Hi-Fi Products
Service Bulletin

Model: TC-RX400/RX50

No. 49R

Subject: No Operation By Remote Commander

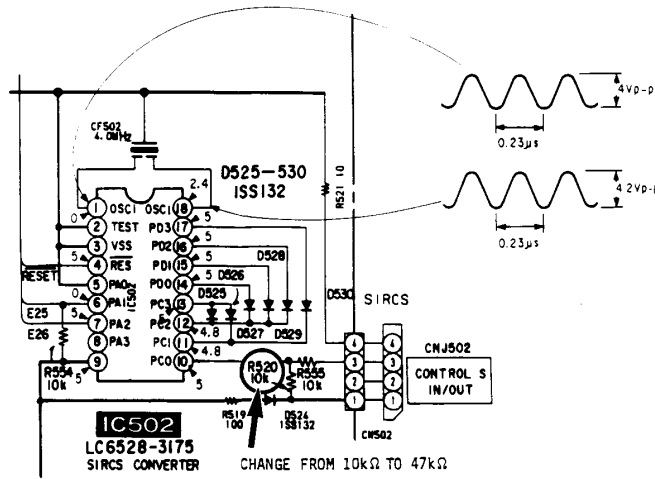
Symptom:
(25)

Remote commands are sometimes not accepted.

Solution: Replace R520 with 47k.

Ref. No.	Former		New	
	Description	Part Number	Description	Part Number
R520	10k	1-249-429-11	47k	1-249-437-11
